Overview: Production error in version 1.0 harnesses; The immobilizer wire (orange/black) is in pin position #4 instead of pin position #5. Although an effort to correct the issue was made, some quantity of harnesses did get shipped before the issue was spotted. We are advising to inspect the harness BLADE connector before attempting to install harness or program the module. This issue is not known to affect the version 2 harnesses, which require no modification.

FTI-STP1: Notas de instalación y configuración

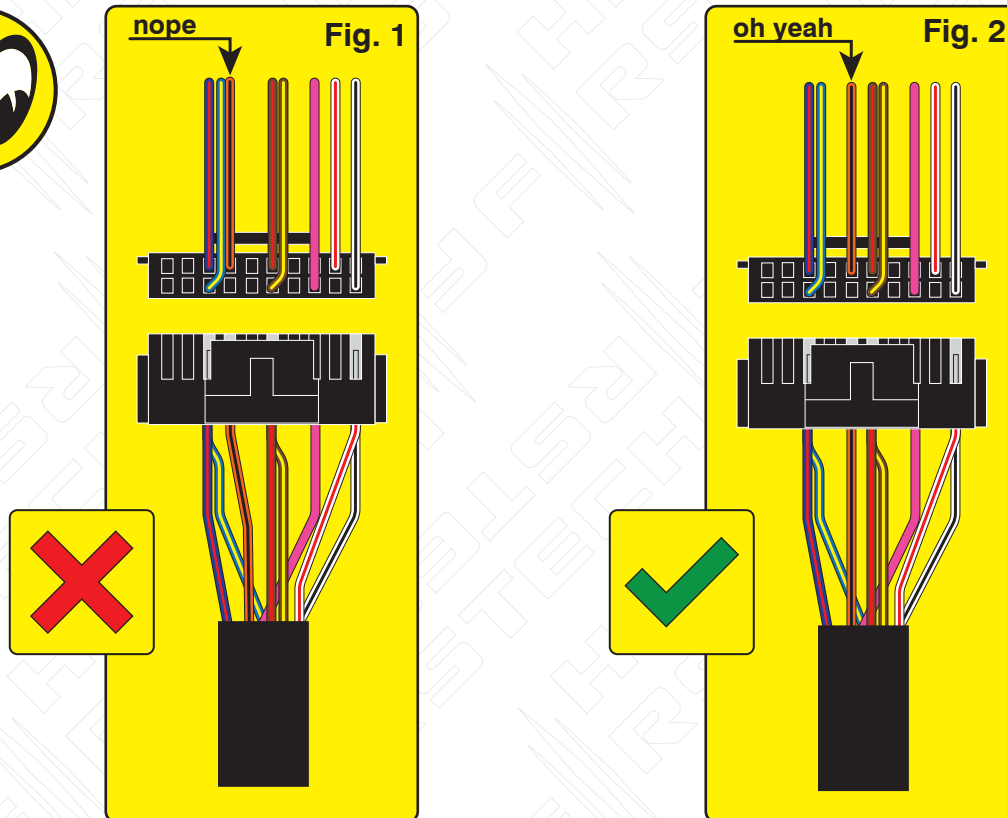
Issue: Module fails to program correctly to vehicle, does not allow the vehicle to be remote started.

Correction: Step 1.) Locate the orange/black wire and confirm whether it is positioned as illustrated in Fig. 1 or Fig. 2. If the wire is as illustrated in Fig.1, proceed with Step 2 through 5 and complete the repair procedure outlined, if the wire is as illustrated in Fig. 2, correction is not necessary, proceed with harness installation and module programming.

Step 2.) Using a pick, lightly depress the catch that secures the terminal in the housing then remove the wire and terminal from the housing.

Step 3.) Using a fine tip razor or utility knife, insert the blade beneath the terminal catch and raise it slightly, so that it can be reused to secure the terminal when reinserted into the BLADE connector housing.

Step 4.) Refer to Fig. 2 for correct position of the orange/black wire (next to brown/red) then reinsert the terminal, pressing lightly until the catch 'snaps' into place, securing the terminal in the connector housing.

MODIFICACIÓN REQUERIDA PARA APLICACIONES A/T, SÓLO CON ARNÉS v 1.0

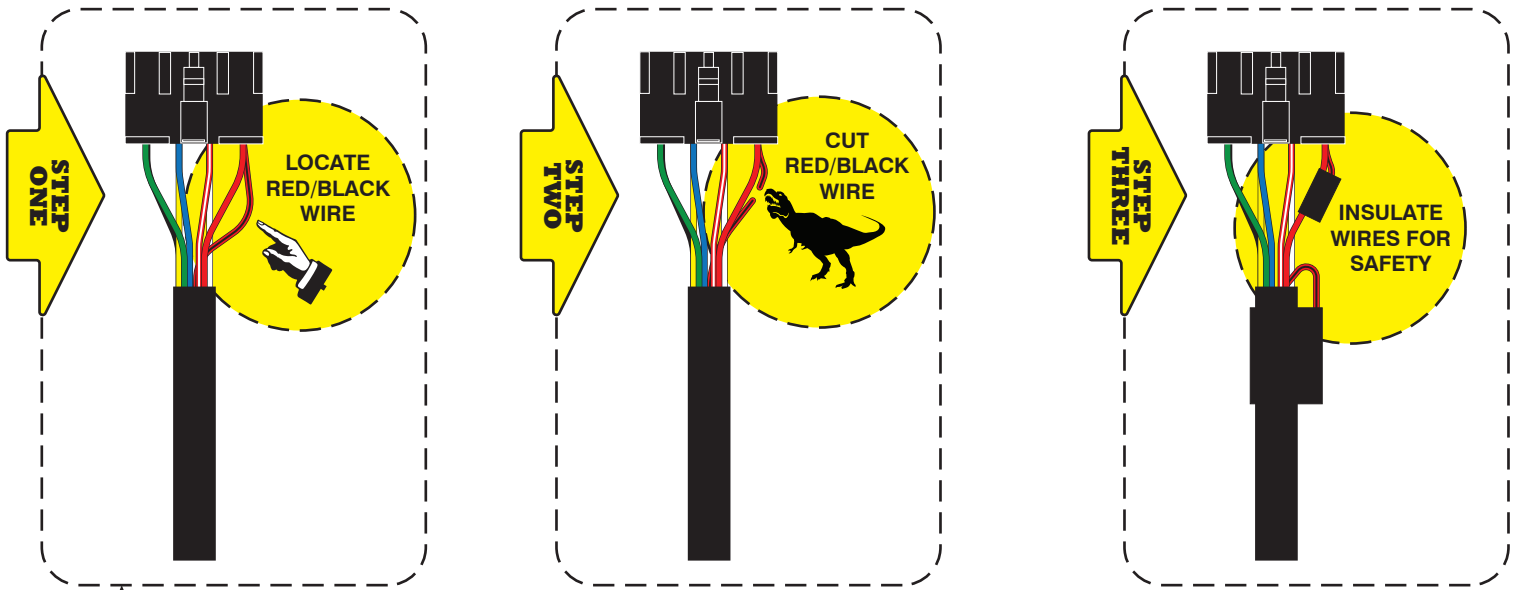
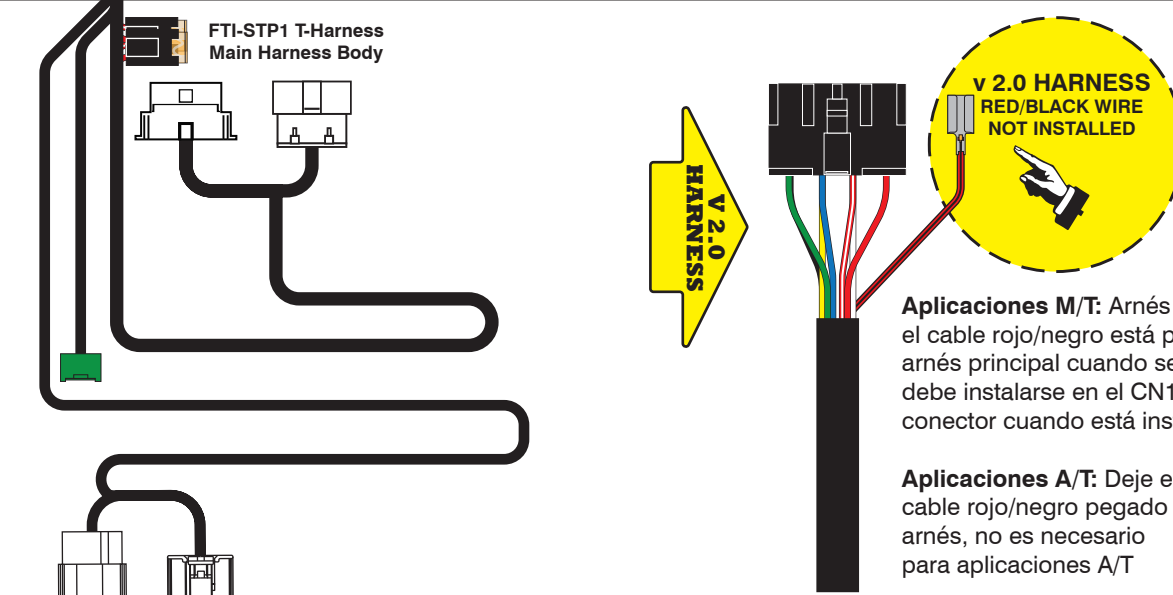
Descripción general: Las primeras versiones del arnés FTI-STP1 requieren modificaciones para aplicaciones de transmisión automática (AT), algunas del producto se pudo modificar antes del lanzamiento, pero una pequeña cantidad se lanzó sin modificaciones.

Problema: El arnés en T FTI-STP1 ha sido diseñado para ser compatible con A/T (transmisión automática) y M/T (manual), pero debido a un descuido en las primeras ejecuciones de producción, la selección se estableció por defecto en el modo M/T.

El uso de un arnés configurado para una aplicación M/T, en un vehículo equipado con A/T, podría provocar daños en el módulo del vehículo, se recomienda que el arnés vuelva al modo A/T antes de la instalación en vehículos equipados con transmisión automática.

Corrección: Localice el cable rojo/negro (+ embrague) proporcionado en el conector CN1 del conjunto del arnés principal. Corte el cable rojo/negro, ya sea al ras del conector CN1 o dejando suficiente cable expuesto para que pueda aislar y asegure los extremos del cable que quedan después del corte. Aísle cada uno de los extremos restantes del cable rojo/negro y asegúrelos para evitar cualquier posibilidad de cortocircuito. Si el cable rojo/negro ya ha sido desconectado, ninguna modificación adicional se requiere para aplicaciones A/T
